URGENT FIELD SAFETY NOTICE

This letter is to inform you of an amendment to the field safety corrective action on the Legendair™ and Supportair™ ventilators, initiated by Covidien in March 2012, related to a potential failure of a component identified as capacitor C53.

**TSB1000014-01 Rev. B
ECO-R206600****International Technical Service Bulletin, Portable Ventilators,
Legendair and Supportair
Revised -Addendum to the Fields Safety Corrective Action**

This PCB needs C53 replaced

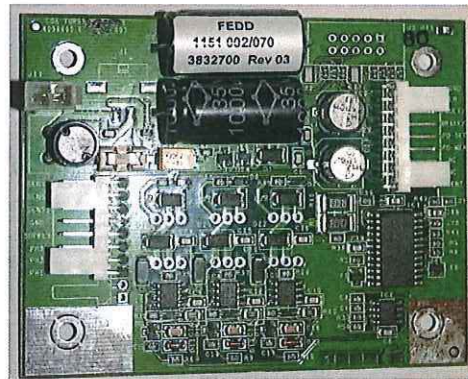
The change is focused on the Turbine Controller Printed Circuit Board fitted within these devices and specifically on the replacement of capacitor C53.

This change is limited to the devices with either Turbine Controller PCB 3812700 or 3812799 installed, and once the device has the new version Turbine Controller PCB 3832799 installed, no further action is required.

1. The New PCB 3832799 can be installed as per the service manual
 - Legendair Service Manual Rev B. Chapter 5 page 11
 - Supportair Service Manual Rev A. Chapter 5 page 12
2. Replacement of the existing 3812799 PCB that contains a new C53 component, is done following the above mentioned service manual references.
3. Replacement of the C53 capacitor on the existing PCB can be performed by the HCP or at a Covidien Technical Services location.

The capacitor has been released as a spare part to allow replacement of this capacitor, part number 10049759, which will be available for order in a pack containing 10 capacitors.
